Environmental Review Team Report

Westwoods Estates

Waterford, Connecticut

March 1981

Vegetation

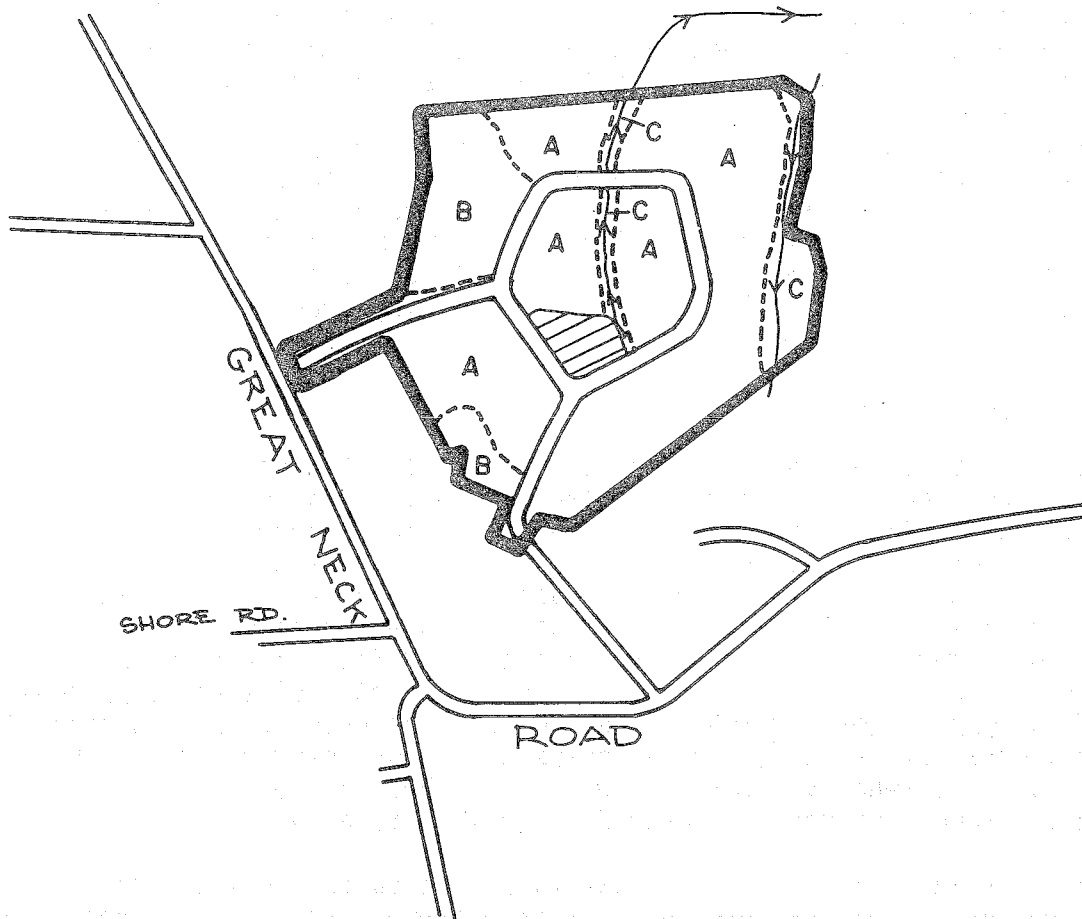
It should be noted that trees are very sensitive to the condition of the soil within the entire area under their crowns. Disturbances such as excavating and grading which disrupt the balance between soil aeration, soil moisture level and soil composition may cause a decline in tree health and vigor, potentially resulting in tree mortality within three to five years. Mechanical injury to trees may cause the same results. Dead trees may become hazardous and expensive to remove if near roadways, buildings or utility lines. The trees which will potentially present a hazard should be located and removed at or before the time of house construction. These trees could be utilized as fuelwood.

Windthrow is a potential hazard in the hardwood swamp/ stream belt areas (vegetation Type C). The trees in these areas are shallow rooted and unable to become securely anchored in the saturated soils. Clearing operations in these areas may accelerate the loss of trees to windthrow.

Some of the red pine in the Pine Plantation (vegetation Type B) are infested with red pine scale. This insect causes unsightly browning of the needles and eventually mortality of the infested trees. No safe effective control is known at this time. Trees which are infested should be removed to help reduce scale population levels and the hazard of dead trees falling. It is probable that this insect will cause mortality in the remaining red pines. It would be advisable to remove these red pine prior to house construction. At first, every other red pine should be removed. In several years, once the rest of the trees have become more stable, the remaining half should be removed. This thinning will benefit the remaining eastern white pine by reducing competition for space, sunlight, nutrients and water.

FIGURE 4

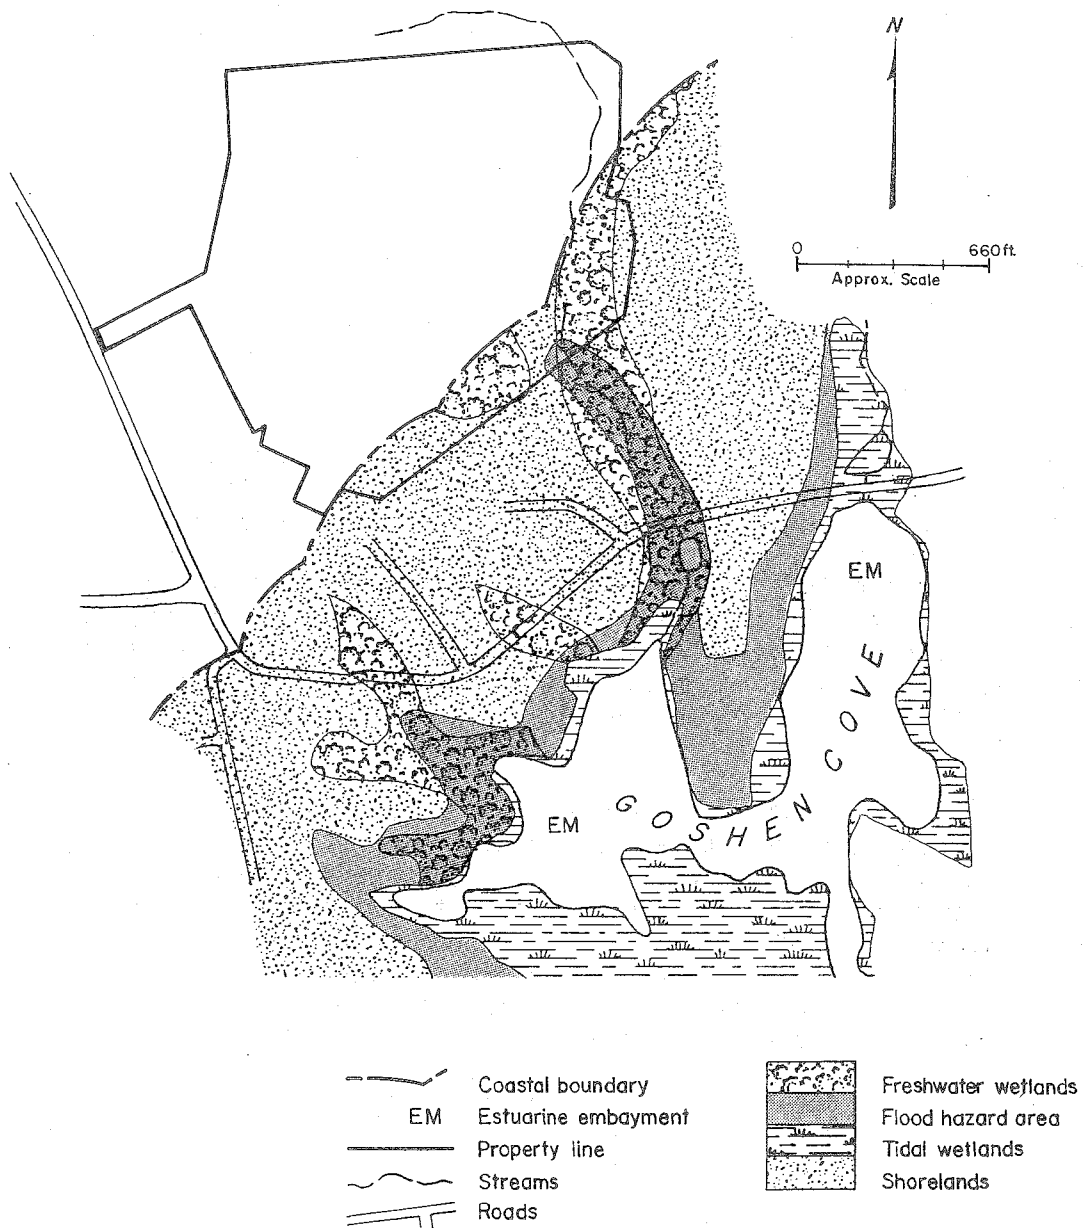
Activities that could potentially generate significant adverse impacts on coastal resources may result from (1) grading, filling, excavation, construction or placement of septic systems in close proximity to existing wetlands and stream borders without the proper erosion/sedimentation controls and (2) erosion, sedimentation and flooding from improper stormwater design and discharge. An appropriate buffer of natural vegetation and soil between the activities listed in 1 above and the stream/wetland will mitigate most of the potential adverse impacts. In especially sensitive areas, snow fences and two rows of offset haybales should be adequate to prevent sedimentation into the wetland and water-course.

As outlined by the developer, stormwater will be discharged directly into the stream that borders the property at two specific sites. Furthermore, the runoff calculations based on a twenty-five year event indicate upwards to a 5-fold increase in runoff. This has the potential to create unwarranted stream erosion, sedimentation and downstream flooding. The applicant must demonstrate that such impacts are acceptable or propose an appropriate modification to the plan which will mitigate these impacts. The simplest solution to direct and uncontrolled release of stormwater is to provide an on-site detention basin for temporary storage of stormwater with delayed release. It is possible that the control swale and wetland could serve as an ideal detention basin with controlled release through an appropriate sized culvert under the proposed paved road.
